**TUEN MUN - CHEK LAP KOK LINK
CONTRACT NO. HY/2013/12 –
NORTHERN CONNECTION TOLL PLAZA AND
ASSOCIATED WORKS**

BASELINE MONITORING REPORT (REV.03)

Response to comments from EPD & PlanD for Baseline Monitoring Report

Figure 1.1 Layout Plan of the Contract

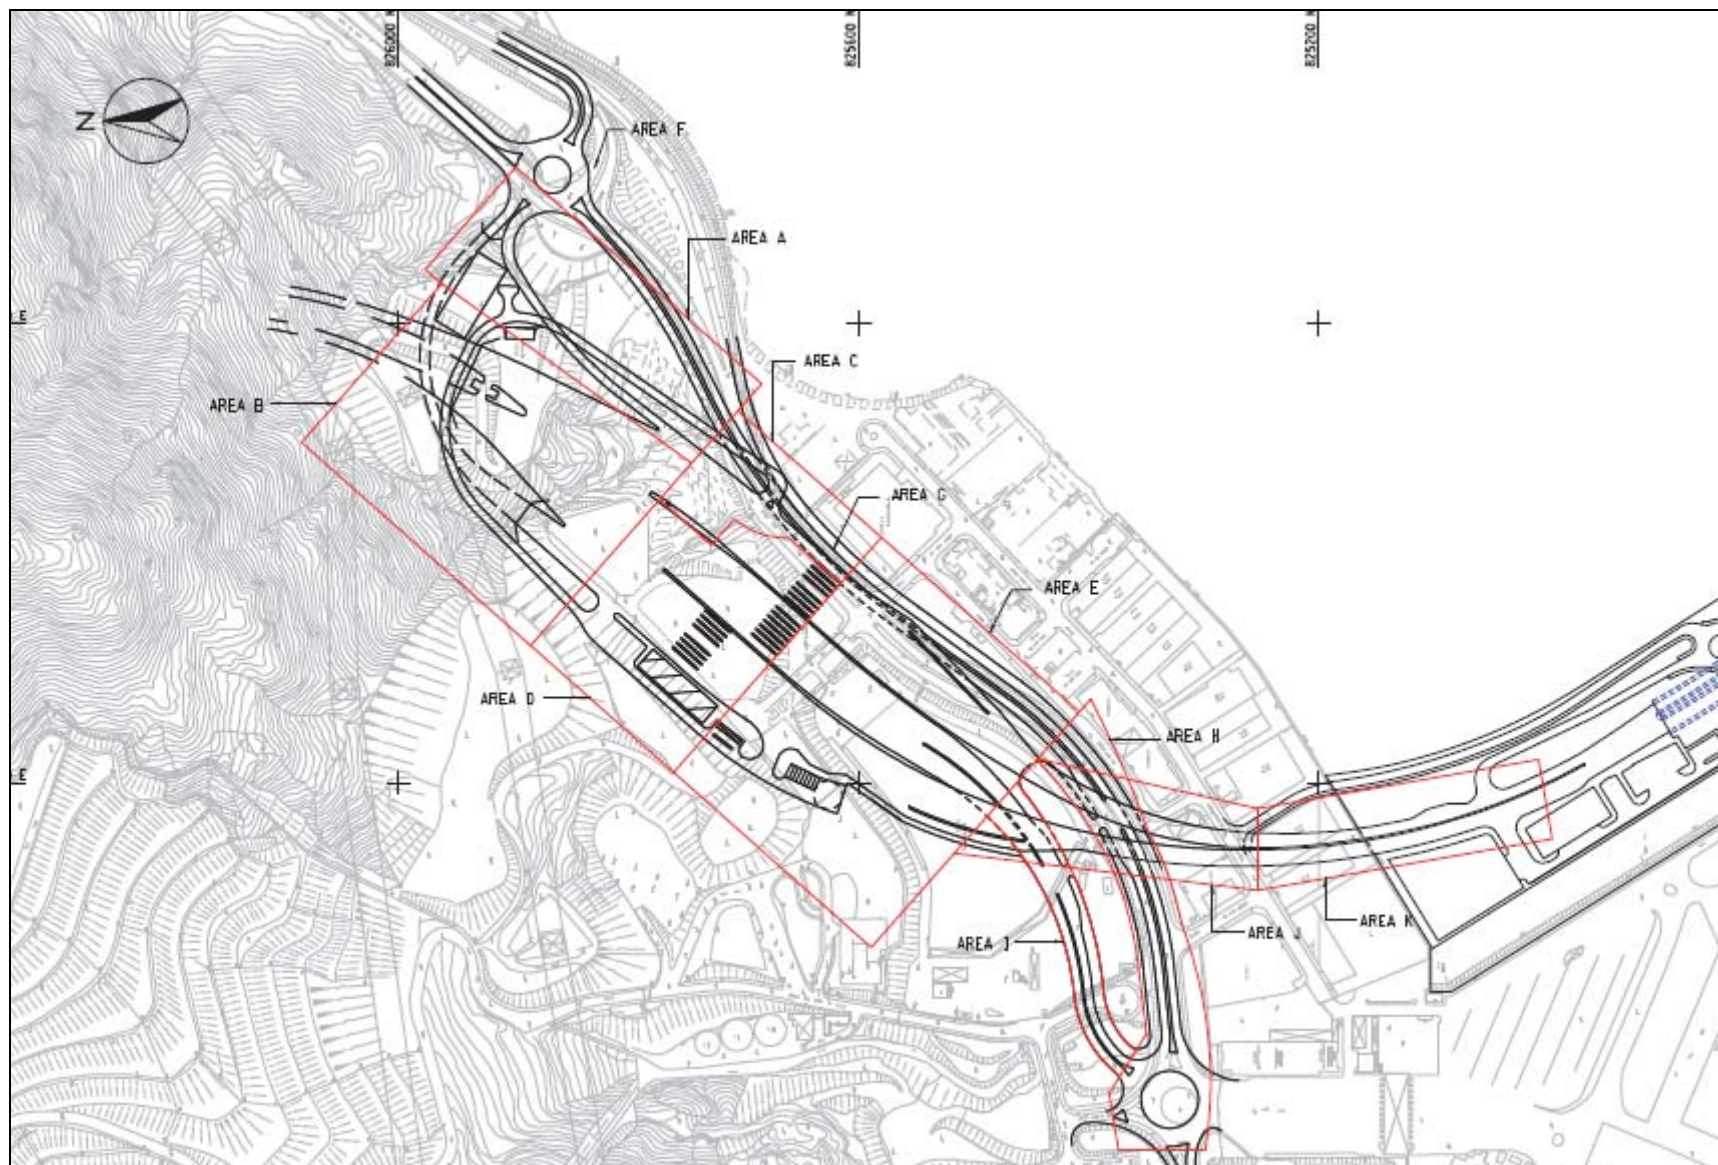
Item	EPD's Comments Ax(9) to EP2/N9/A/125 (II) dated 3 July 2015	Contractor's Response
2	The interface/scope of the different contracts under the Project (preferably with a plan showing the boundary of the various contracts) shall be provided to clearly set the scene for the viewing of this report. The various LR/LCAs as mentioned in the EIA to be covered by this contract and other TM-CLKL contracts shall be clearly spelt out to avoid confusion.	Noted, a plan showing various contracts of TM-CLKL was added in figure 1.2 to 1.5 . Various LR/LCAs as mentioned in the AEIAR were all added into the revised report, please refer to item d, f and i below.
